Tri-Hex Power Dish

Introducing the new Tri-Hex Power Dish from Diamond Mowers Inc.

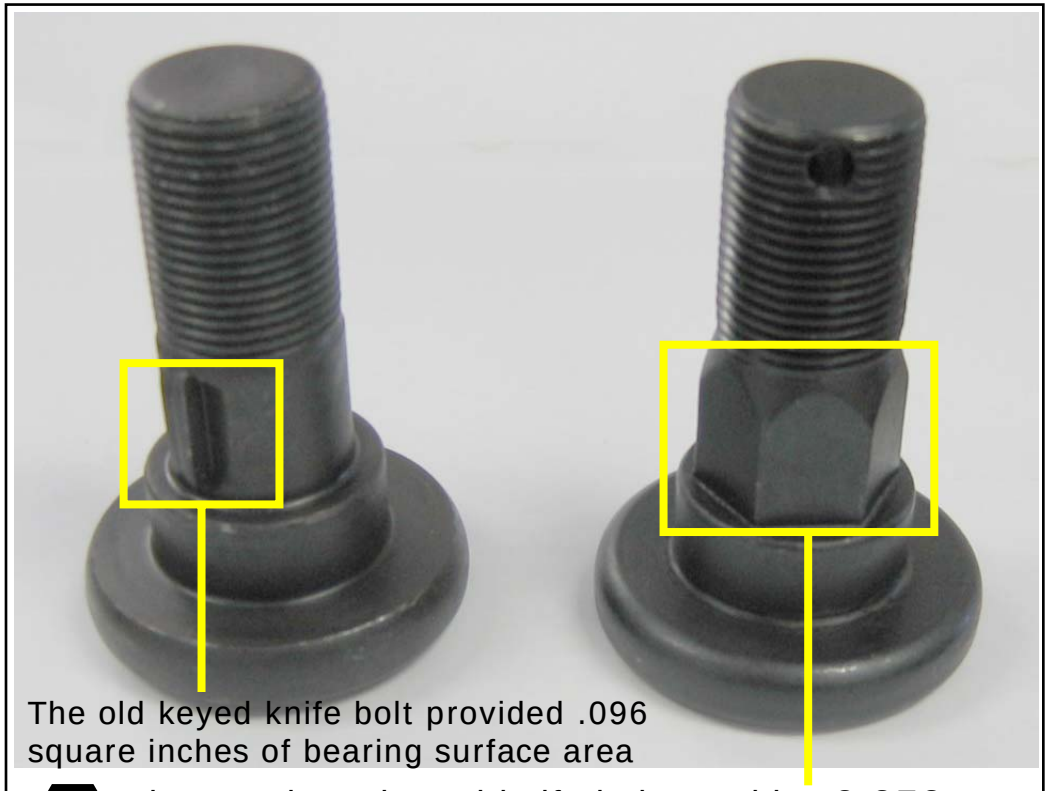
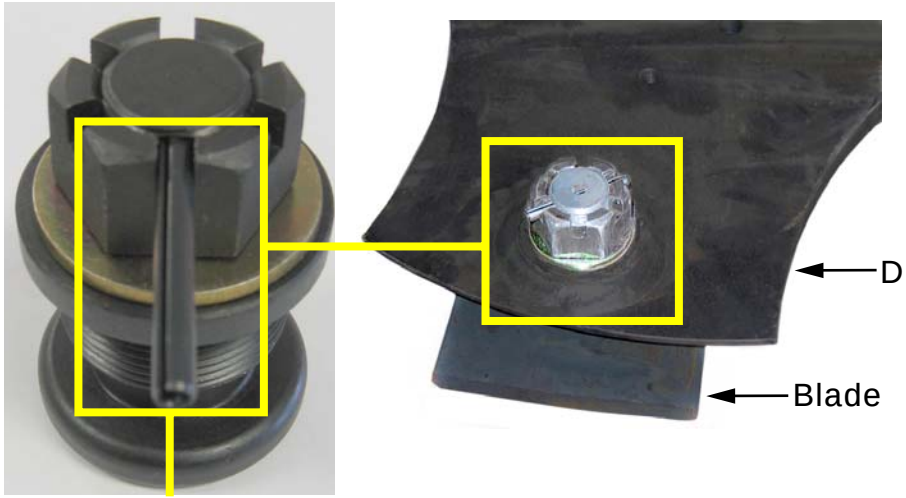
The new hex shaped knife bolt and hardened dish insert prevents the elongation of the knife bolt mounting holes in the dish. It also prevents excessive wear on the bolt itself, which eliminates knife tipping and canting.
The Tri-Hex Power Dish will be standard on all Diamond Mowers dishes starting **March 1st 2007**.

The old keyed knife bolt provided .096 square inches of bearing surface area

The *new* hex shaped knife bolt provides **3.372** square inches of bearing surface area

The roll pin is hammered through the castle nut then the knife bolt, eliminating the potential of the nut loosening

The replaceable hardended insert is threaded ***and*** welded into the dish
